Re: **Public Hearing** – Application of Juan Campos for Preliminary Plan approval of a 5-lot subdivision including extension of an existing town road. The property is located at the end of Serenity Drive, with frontage also on Maidford River Road, and is identified as Tax Assessor's Plat 120, Lots 68-A & 68-B.

Subject: Serenity Drive Subdivision, Detention Basin Groundwater Mounding

RE: Response to Continuous Technical Review Comments
Campos Residential Subdivision
Plat 120, Lots 68A & 68B

PELIMINARY PLAN REVIEW MEMORANDUM

Scale: 1"=30'	Date: 27JAN22	Designed By: JJR	Drawn By: JJR	Checked By: GES
Project Title: CAMPOS SUBDIVISION SERENITY DRIVE, MIDDLETOWN RI		Drawing Title: DETENTION BASIN GROUNDWATER MOUNDING		
Issued for: PERMITTING		Drawing Number: C-1	Project Number: 19187.0

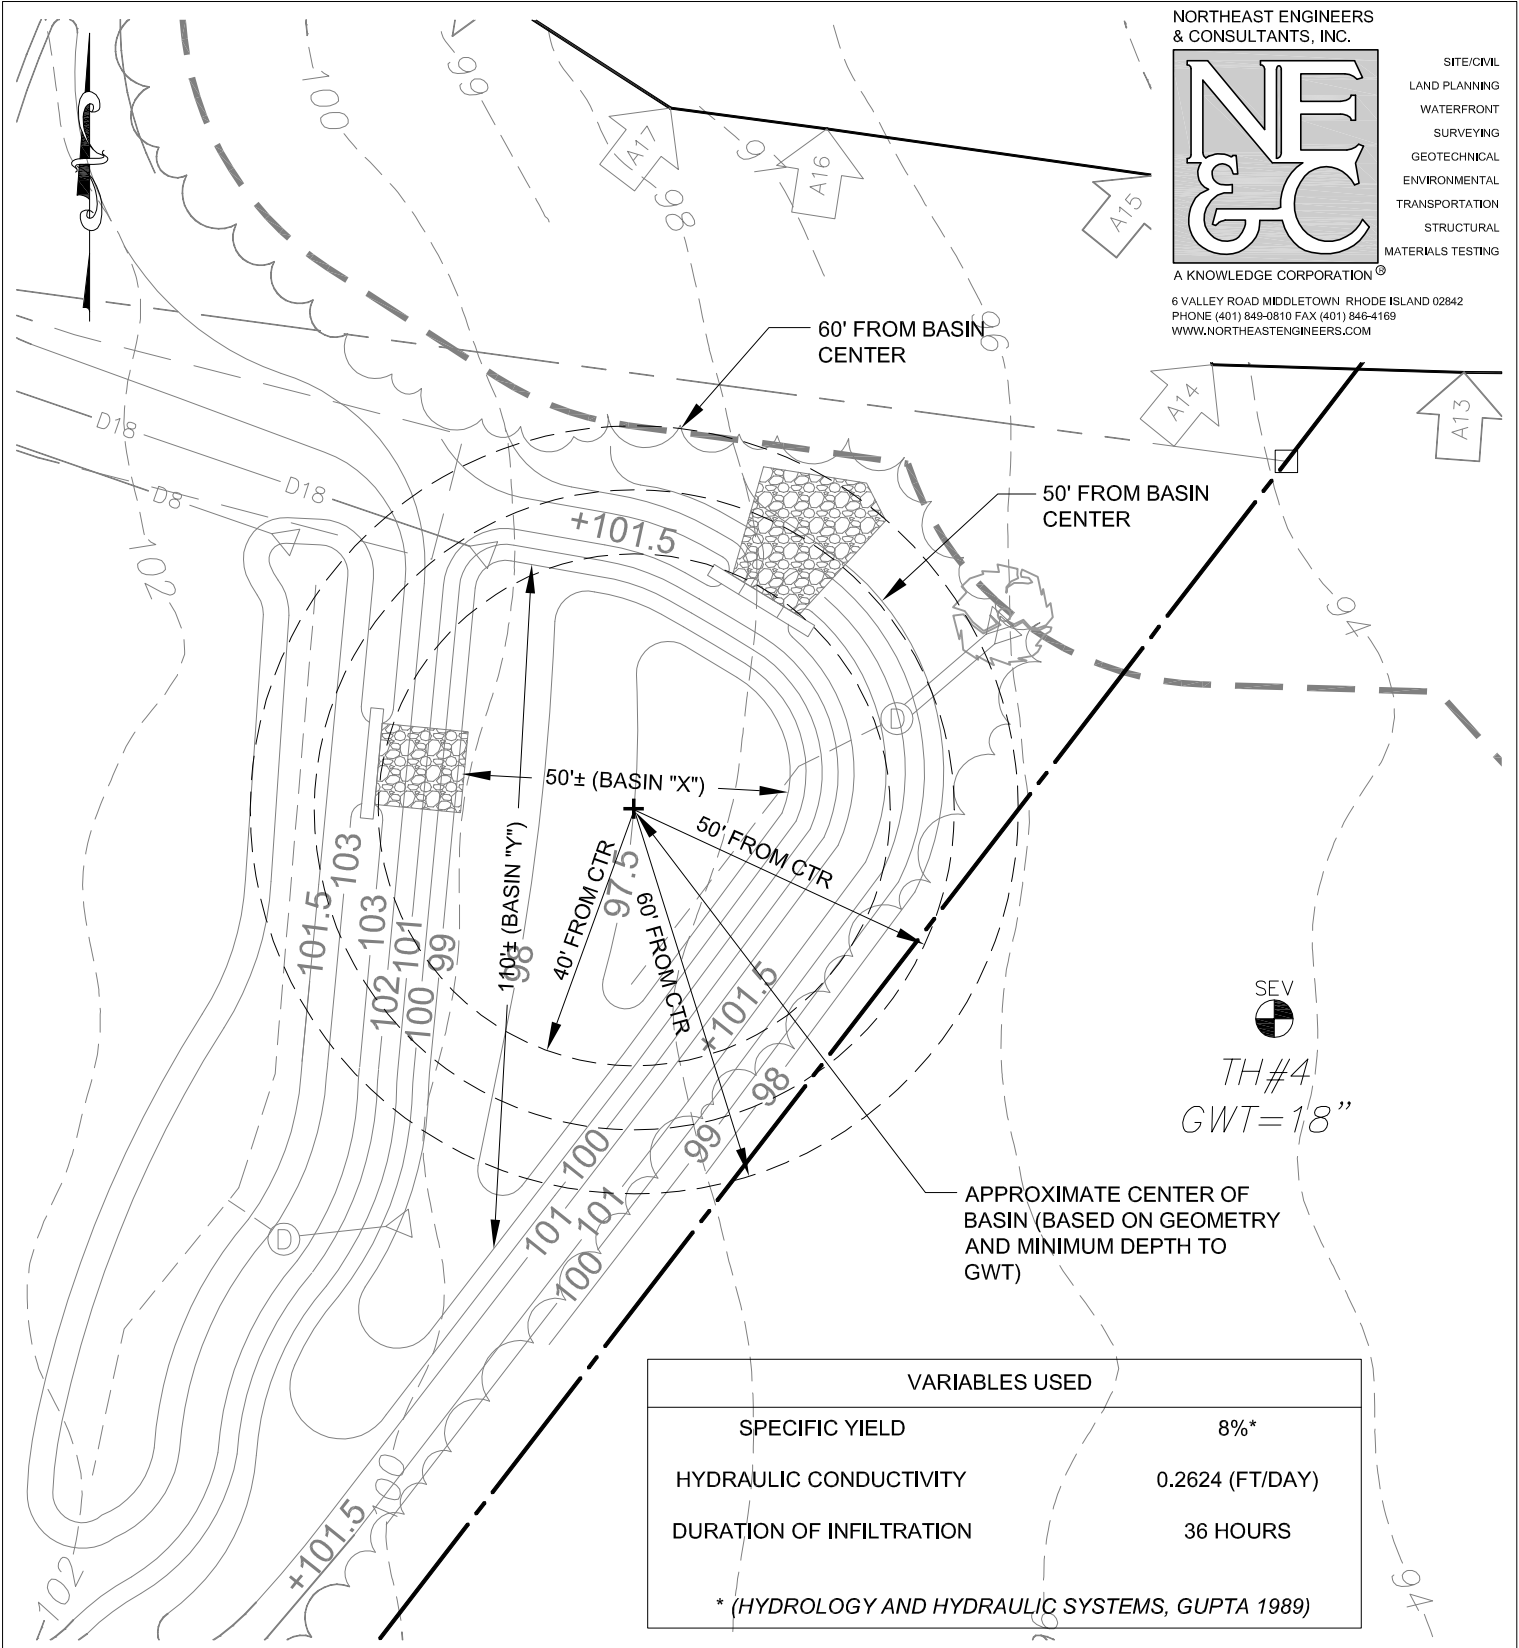
Pursuant to the continued concerns raised by the town third party reviewer regarding the separation between the bottom of the proposed infiltrating detention basin to the estimated seasonal high groundwater table, Northeast Engineers & Consultants, Inc. (NE&C) has prepared the following groundwater mounding analysis.

As is shown in the results from this analysis, the highest points in the resulting mound are within 20 feet of the center of the basin. As this is still within the extents of the basin, groundwater break out is not possible. The following table shows the height of the resulting mound, the maximum groundwater elevation, and the proposed grades for distances outside of the proposed detention basin.

As evidenced by these results, the potential for groundwater breakout as a result of mounding groundwater is extremely low. This can be attributed to the relative size of the proposed basin, and the limited infiltration capacity.
